Addendum 1 -- 2452
To
IMPACTED MATERIALS PLACEMENT PLAN
ON-SITE DISPOSAL FACILITY

Specialized Placement Plan
for Bagged Impacted Material

20100-PL-007

Fernald Environmental Management Project
Fernald, Ohio

FIGURE 1 - TYPICAL SECTION
BAGGED IMPACTED MATERIAL PLACEMENT

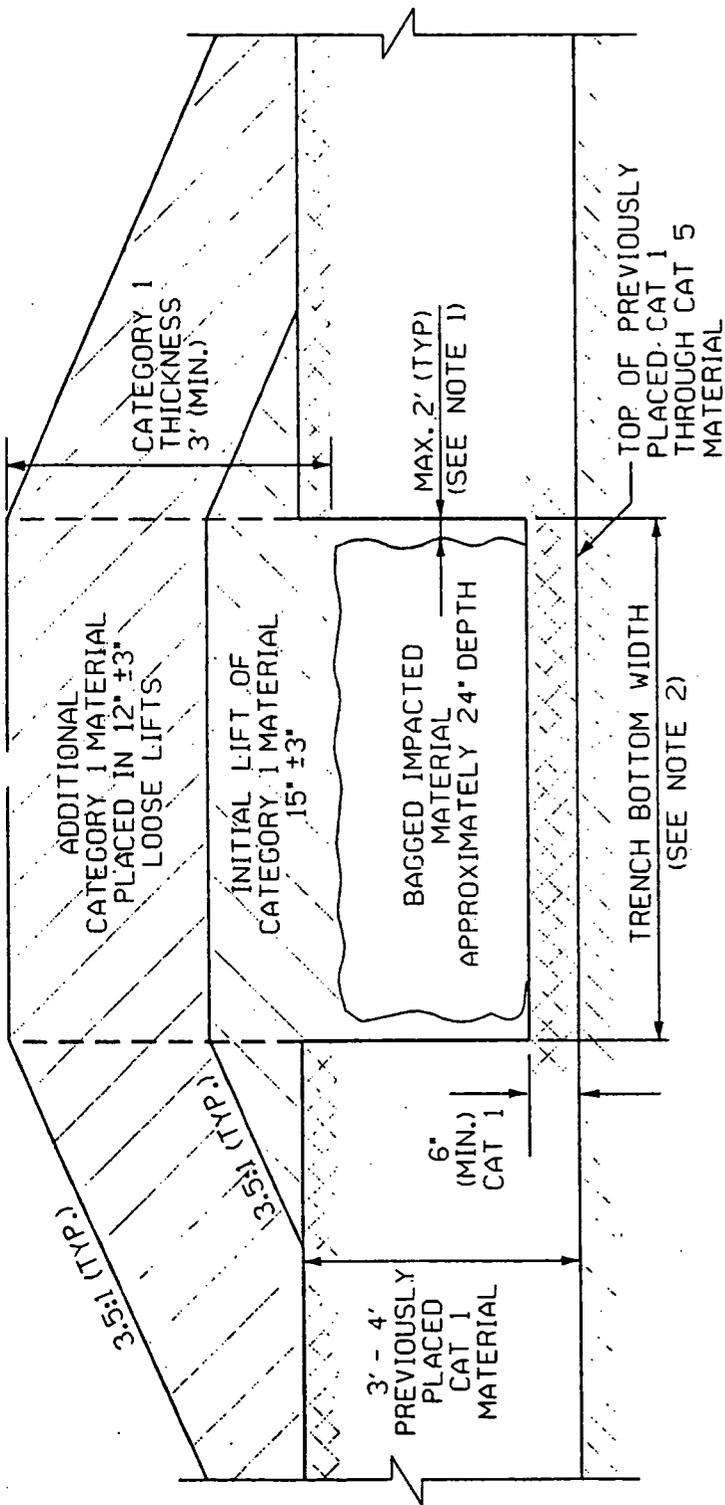
A trench for bagged material placement in the approved grid(s) location shall be excavated, as shown in attached Figure 1. The bottom of the trench shall have minimum of 6 in (150mm) of Category 1 material above a previously placed Category 1 through 5 material. The trench shall not be excavated in previously placed protective, contouring, or select impacted material layers. The width of the trench shall be approximately the width of the

transporting container for the bagged impacted material plus 2 ft (0.6m). The width of the trench is anticipated to be approximately 8 ft (2.4m) to 12 ft (3.6m). Category 1 impacted material excavated from the trench shall be stored at least 6 ft (1.8m) away from the trench opening. The length of the trench shall vary depending on the quantity of bagged impacted material to be placed in the OSDF. The depth of bagged impacted material in the trench shall be approximately 24 in (600mm). The maximum distance between the bag(s) placed in the trench and trench walls and between the bags shall be 2 ft (0.6m). The placement of bagged impacted material shall be performed in accordance with Fernald Environmental Management Project (FEMP) radiological safety procedures, as well as the contractor's Safe Work Plan, to minimize worker exposure.

Compaction shall not be performed directly on the bagged impacted material. Contact with the bagged material shall be minimized by personnel and equipment. After placement of the bagged impacted material in the trench, void spaces between the bags and between the bags and trench walls shall be filled with Category 1 material. The Category 1 material filled in void spaces shall not be compacted. An initial lift of 15 in (376mm) \pm 3 in (76mm) thick Category 1 material shall be placed over the bagged impacted material. The top of the initial lift shall be compacted with a minimum of four passes of a portable flat-plate, self-propelled double drum roller compactor, or a smooth drum vibratory roller and shall not require compaction testing. Additional 12 in (300mm) \pm 3 in (76mm) thick Category 1 lifts shall be placed above the initial lift. Total thickness of Category 1 material placed above the bagged impacted material, including the initial lift, shall be a minimum 3 ft (0.9m) as shown on attached Figure 1. The Category 1 lifts above the initial lift shall be compacted by a CAT 826 compactor, CAT 815 compactor, or equivalent, to meet at least 90 percent of the standard Proctor dry density. The compaction shall be tested in accordance with the IMP Plan.

- NOTE 1. MAXIMUM DISTANCE BETWEEN THE BAG(S) OF IMPACTED MATERIAL AND BETWEEN TRENCH WALLS AND THE BAG(S) SHALL BE TWO FEET.
- NOTE 2. THE WIDTH OF THE TRENCH SHALL BE APPROXIMATELY THE WIDTH OF THE TRANSPORTING CONTAINER PLUS 2 FEET. (WIDTH ANTICIPATED TO BE APPROXIMATELY 8 TO 12 FEET)
